174 Palatine rd, West Didsbury, Manchester

Variation application description.

Application number: 134924/JO/2022

Proposal: Variation of condition number 2 (specified plans) from planning approval reference 128895/FO/2020 to allow design changes including the introduction of additional windows and reconfiguration of dormers and roof lights together with amendments to the landscaping scheme incorporating a revised vehicular access to the site and the amendments to the rear car parking.

Amendments to typical plan

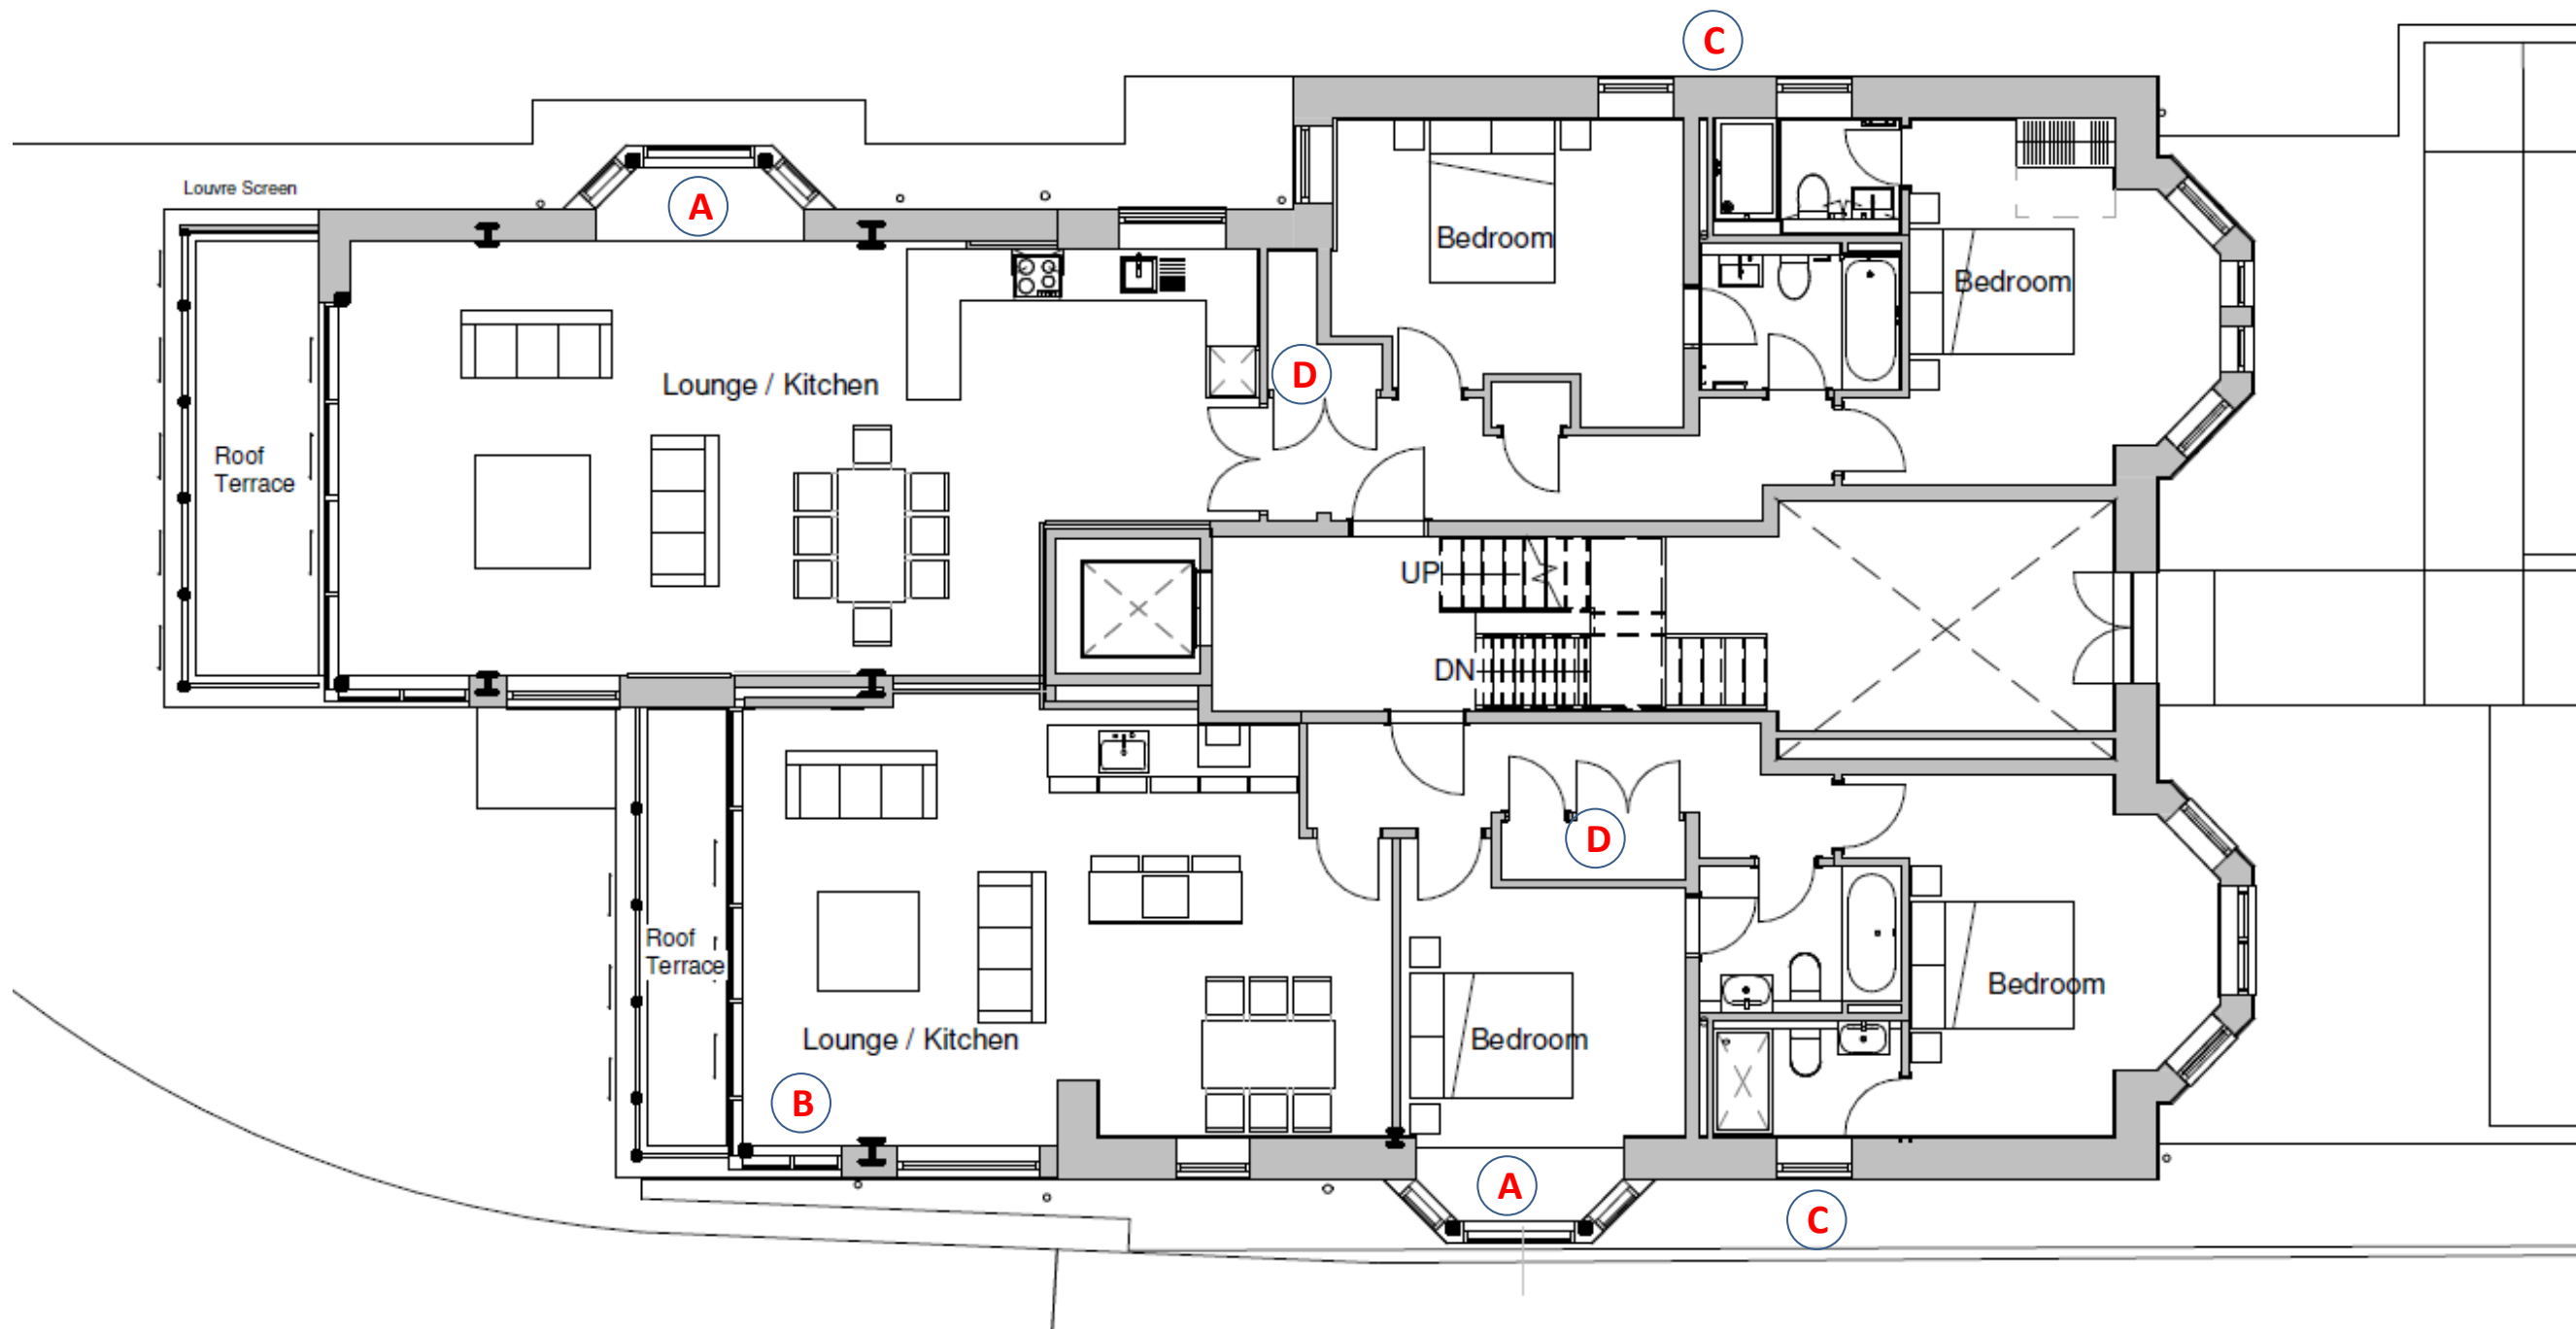
The proposed variation plan has remained almost exactly as the approved plan. The elements that have been revised have been reviewed to improve the quality of the flats by increasing the amount of light that enters the flat and improve the geometric balance of the side elevations.

A: Bay windows added to the South and North Elevation. Proportion and light entering the affected rooms improved.

B: South West facing windows to the living space wrapped around the corner.

C: Window openings to the north and south elevation of the existing building, most of which are existing, will be re-located or added to, a small amount to tidy the elevation geometry. These elevations have become more prominent as the neighbouring buildings/sites have changed and the currently disorderly windows will benefit from adjusting position, aligning and filling in missing teeth.

D: Additional cupboards and or additional cupboard space.

FRONT ELEVATION.

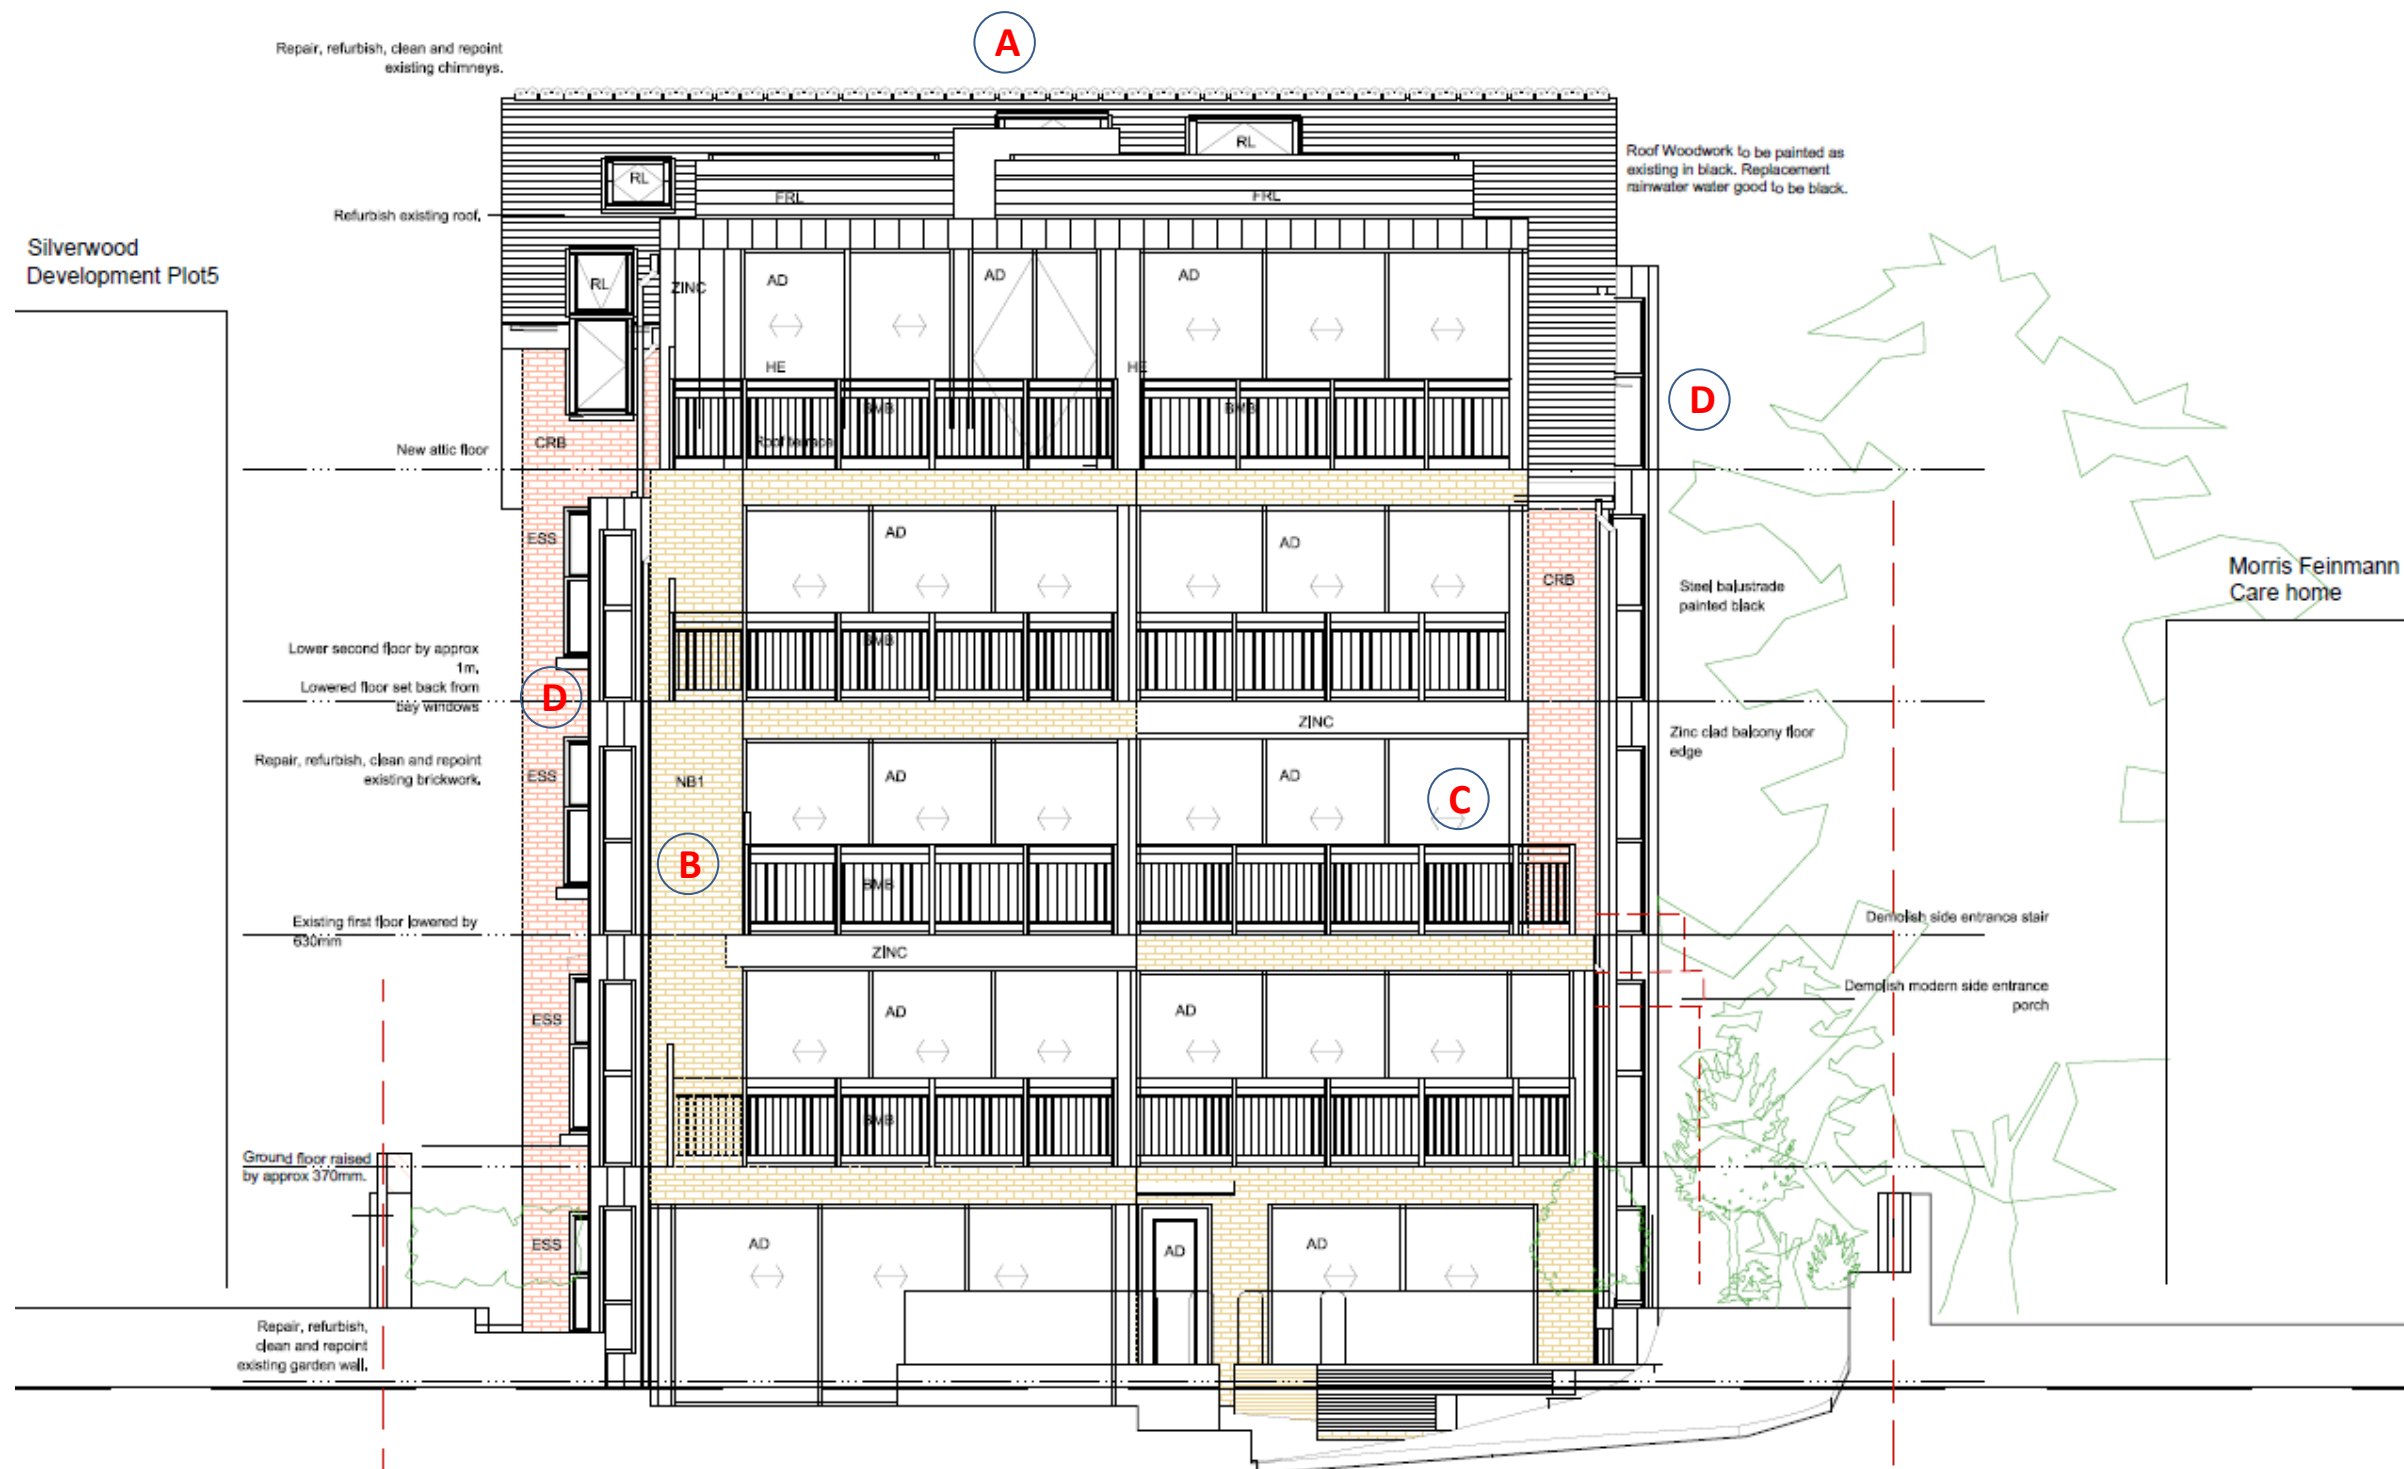
The proposed variation elevation has remained almost exactly as the approved elevation. The elements that have been revised have been reviewed to improve the quality of the flats by increasing the amount of light that enters the flat and improve the geometric balance of the side elevations.

A: Window heights to the dormers increased to improve light in the rooms and views out.

B: Velux Roof light joined with vertical Velux window.

C: Window openings to first floor to the front elevation increased in height.

D: South side elevation bay window.

REAR ELEVATION.

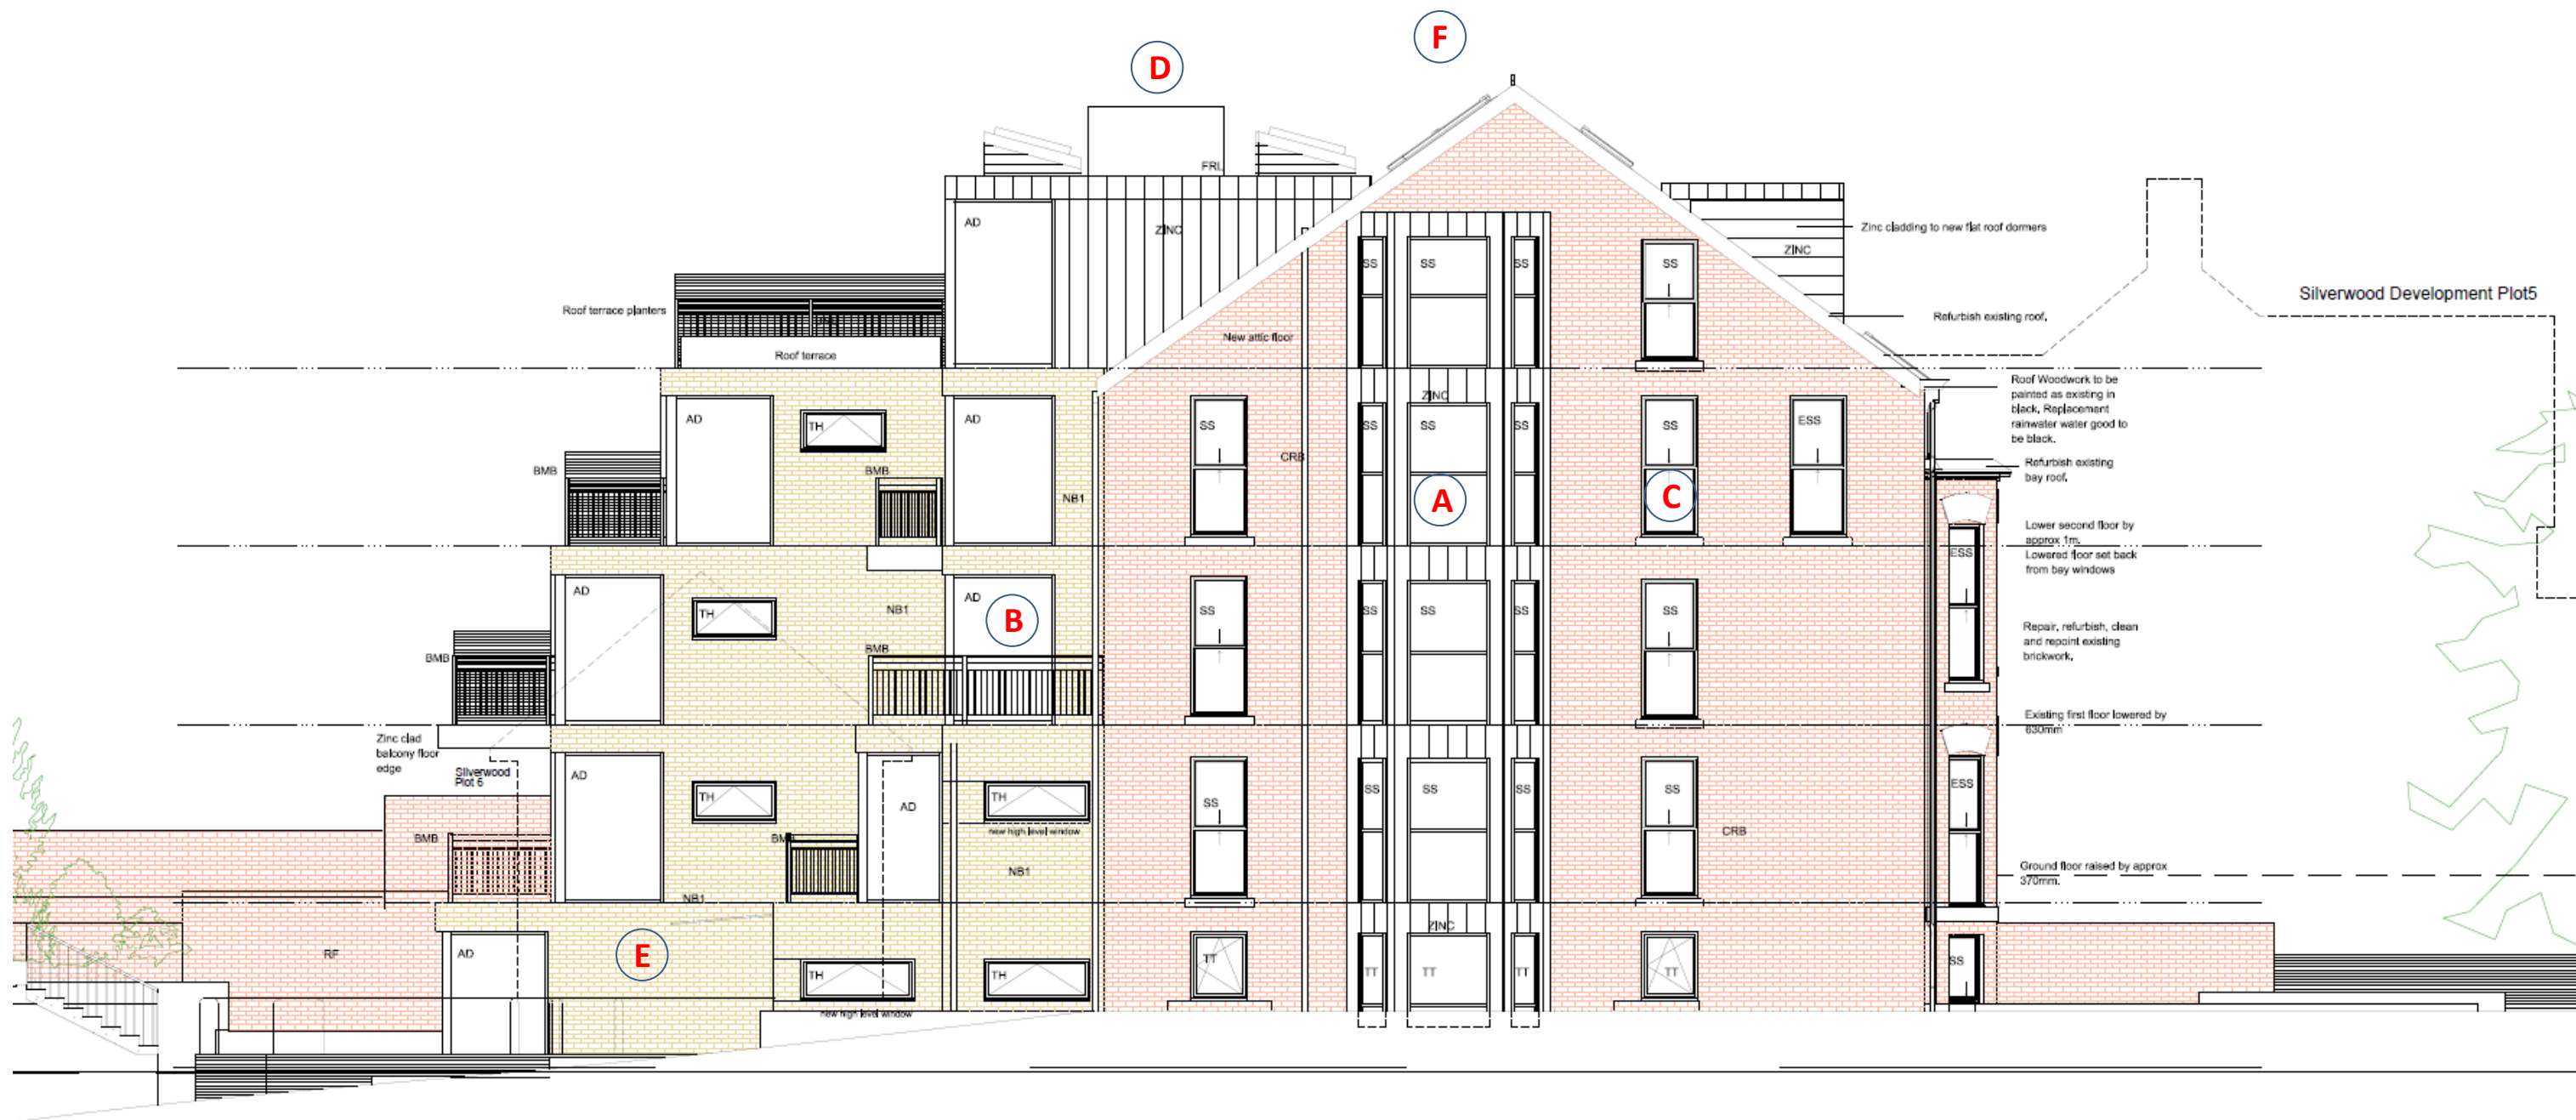
The proposed variation elevation has remained almost exactly as the approved elevation. The elements that have been revised have been reviewed to improve the quality of the flats by increasing the amount of light that enters the flat and improve the geometric balance of the side elevations.

A: Requirement for Lift machine room has increased the height of the lift tower.

B: A new Buff brick specified instead of the originally specified red brick.

C: Window fenestration adjusted to have less vertical members/panes.

D: South and North side elevation bay windows.
